Access Compliance Report

Public Rights-of-Way

Intersection ID: 3217	Main Street: CARVER_POND_RD	Cross Street: SPRING_PARK_DR	Location: S
ADA ID: ADCF8874D9BE	Ramp Type: PerpDiag	Initial Pass/Fail: Fail	Overall Compliance: No
			Severity Score: 18.75

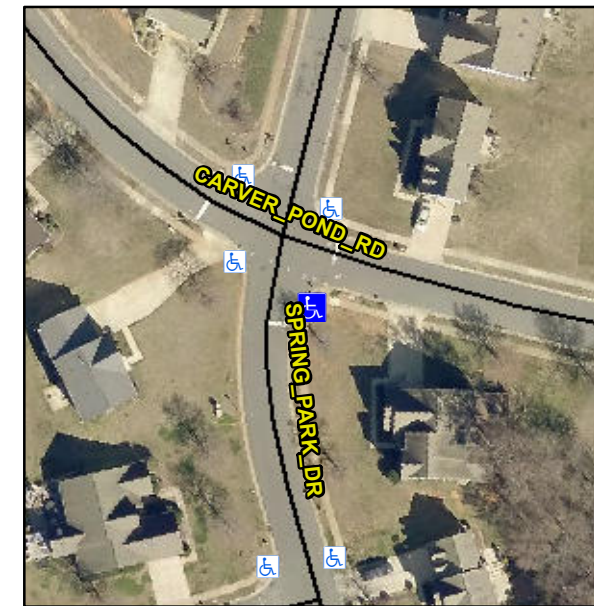
Not Found, R304.5.1, R304.5.3

Compliance	Description	Data	Compliance	Description	Data
N/A	Ramp Length (in)	48.0	Yes	Ramp Slope (%)	5.1
No	Ramp Width (in)	35.0	No	Ramp XSlope (%)	3.0
N/A	Flare Type LT	N/A	N/A	Flare Type RT	N/A
N/A	Flare Slope LT (%)	N/A	N/A	Flare Slope RT (%)	N/A
N/A	Flare Traversable LT?	N/A	N/A	Flare Traversable RT?	N/A
N/A	Landing Length (in)	N/A	N/A	DWS Provided?	N/A
N/A	Landing Width (in)	N/A	N/A	DWS Contrast?	N/A
N/A	Landing Slope (%)	N/A	N/A	DWS Length (in)	N/A
N/A	Landing X Slope (%)	N/A	N/A	DWS Full Width?	N/A
N/A	Landing Curb? (Y/N)	N/A	N/A	DWS Offset (in)	N/A
N/A	Shared Landing?	N/A			
N/A	Gutter Ponding?	N/A	N/A	Gutter Slope (%)	N/A
N/A	Gutter Lip Ht (in)	N/A	N/A	Gutter X Slope (%)	N/A
N/A	Painted X Walk1?	No	N/A	Painted X Walk2?	No
	X Walk 1 Direction	To NE		X Walk 2 Direction	To NW
N/A	X Walk 1 Width (in)	N/A	N/A	X Walk 2 Width (in)	N/A
	X Walk 1 Slope (%)	5.8		X Walk 2 Slope (%)	7.6
	X Walk 1 X Slope (%)	4.4		X Walk 2 X Slope (%)	4.8

Remove & Replace Curb Ramp With Two New Directional Ramps or Equivalent.
